Shop Drawing Submittal Review

Project Name: Webster University-**ISB**

SPEC SECTION: 22 4216.16
Commercial Sinks

RE: Sinks Product Data

PFPTB101

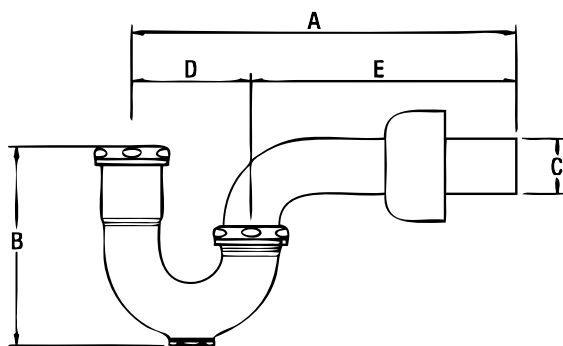
Escutcheons are specified to be cast brass. Refer to specification section 220518.
